# ANYTEK

TITLE		YC 5.08 Series 2P-24P			
PART NO.		YCxx21x0xxxxG		DWG NO.	8YC0001
APPROVED	CHECKED	DESIGNED	DRAWN	CUST NO.	
		Kind 2009.01.08	Kind 2009.01.08		
					Tolerance
					UNIT: mm
				SCALE: NONE	X.X ±0.30
				SHEET: 01/01	X.XX ±0.10
				REV.: G	X° ±1°

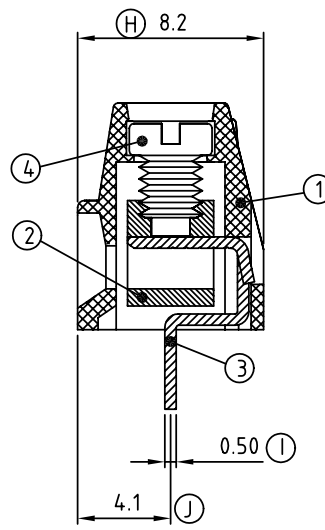
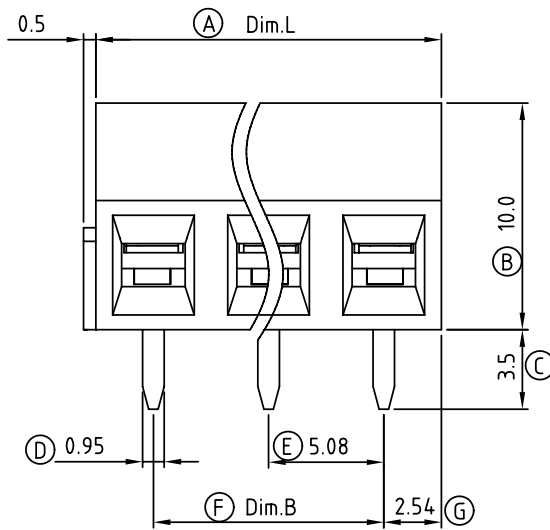
SIGN	DATE	DESCRIPTION	APPROVER
△	01/18/07	Soldering temperature changed from 245° to 250°	Tason
△	01/18/07	Part NO is Changed	Tason
△	01/08/09	Temperature changed from -30°C~+105°C to -40°C~+115°C	Kind
△	01/08/09	Terminal screw changed from M2.5 to M3.0	Kind

- Voltage rating: 300VAC
- Current rating: 10A
- Wire range:
  - Solid wire(AWG): 16-26
  - Stranded wire(AWG): 16-26
  - Torque(Lb-In): 3.5
- △ ● Screw: M3.0
- Wire strip length: 6-7mm
- Withstanding Voltage: 1.6KV
- △ ● Operating temperature: -40°C to +115°C
- △ ● Soldering temperature: 250°C±10°C/5 Sec
- Safety Approval: us
